Anthropomorphic phantom dosimetry and validation of 150–200 MeV very high-energy electron radiotherapy at CERN

This file contains all reviewer reports in order by version, followed by all author rebuttals in order by version.

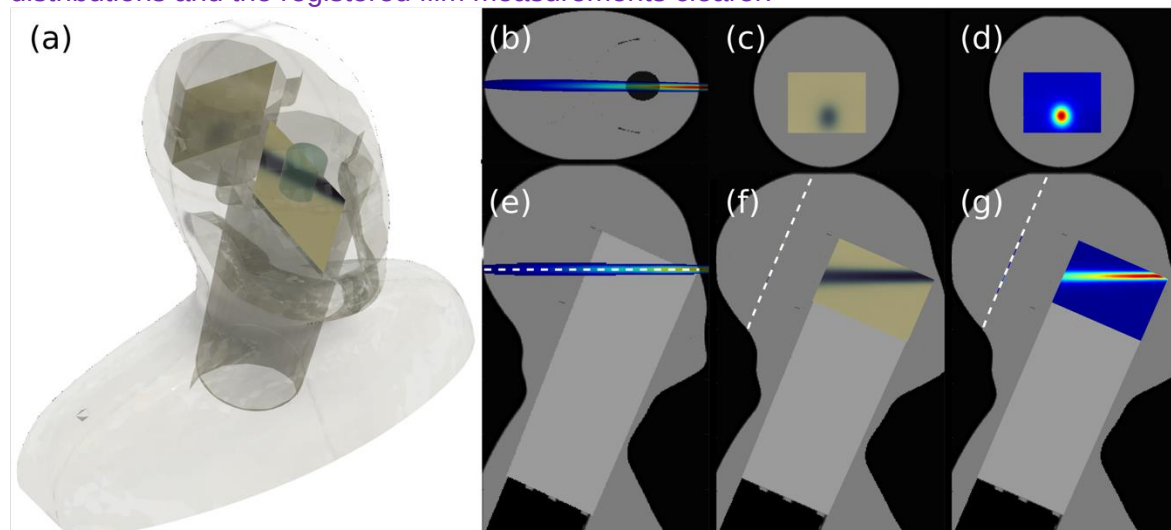
3. In Fig. 3, the 3D render of the phantom is blurry and the way the slice views are presented is confusing. It’s not at all clear that Fig. 3(b)i is the axial slice of the whole phantom head, while Fig. 3 (c)i and Fig. 3(d)i are (presumably) the coronal slice of the back part of the phantom head. This figure could be made clearer by being consistent in where the slice views are located with respect to the phantom or world/beam axis.

>> 3. In Fig. 3, the 3D render of the phantom is blurry and the way the slice views are presented is confusing. It's not at all clear that Fig. 3(b)i is the axial slice of the whole phantom head, while Fig. 3 (c)i and Fig. 3(d)i are (presumably) the coronal slice of the back part of the phantom head. This figure could be made clearer by being consistent in where the slice views are located with respect to the phantom or world/beam axis.

We agree that the original Fig. 3 caption and panel labelling were unclear. We have revised the figure presentation and caption to define the slice orientations more explicitly. The updated caption now distinguishes the 3D-rendered whole-phantom view from the sagittal and posterior oblique film/slice views, and indicates that the dashed lines in the sagittal panels mark the location of the posterior oblique plane shown in the corresponding panels. This should make the relationship between the 3D phantom rendering, the CT slices, the MC dose distributions and the registered film measurements clearer.

“Methods, Section 4.6.1

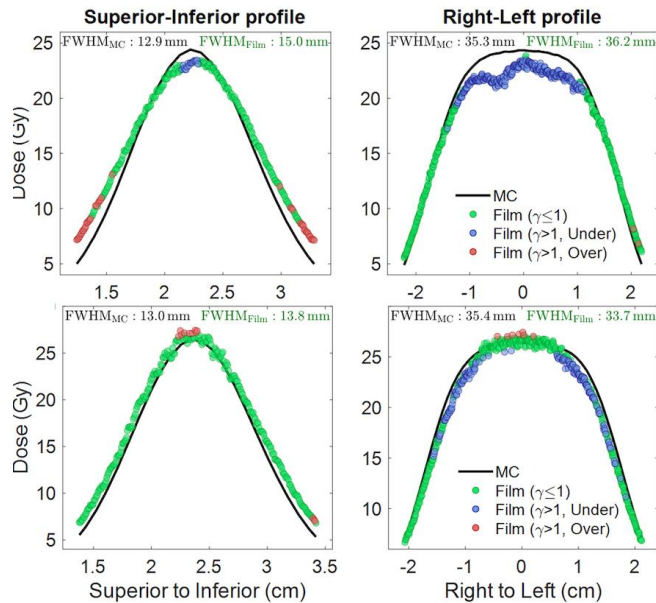
8. The effect of scattering due to the EBT-4 film (which might not necessarily be water-equivalent) was not addressed. It might or might not explain some part of the difference between simulation and film measurement. There is also no clear justification for the choice of EBT-4 over other types of EBT film (it may simply have been the only option available at the time of the experiment).

We agree that this should have been stated more clearly. As noted above in response to Reviewer 2, the EBT-4 film was not treated only as an idealised measurement plane: the film was included in the MARVIN Monte Carlo geometry at the experimental measurement locations, so potential local perturbations from the film were represented in the simulation. We have revised the Methods to clarify this point. We have also added a brief rationale for using EBT-4, namely its high spatial resolution and suitability for dosimetry in small, steep-gradient VHEE fields.

...The MARVIN model incorporated its ABS structure, interchangeable inserts (either ABS for tissue-equivalence or low-density polyurethane foam with a density of $\approx 0.05 \text{ g/cm}^3$ to simulate air cavities), internal air cavities, and the EBT-4 films (polyester, thickness 300 μm , density 1.35 g/cm^3) at the experimental measurement locations used for comparison with the film dosimetry data. Material properties were based on standard compositions or, for specific components like the foam, defined explicitly. For MARVIN simulations, AUTOMC performed the mapping of CT Hounsfield Units to material definitions (ABS, foam, air) and their respective densities. The inclusion of the film geometry was used to account for potential local perturbations to fluence and dose deposition at the film measurement planes...”
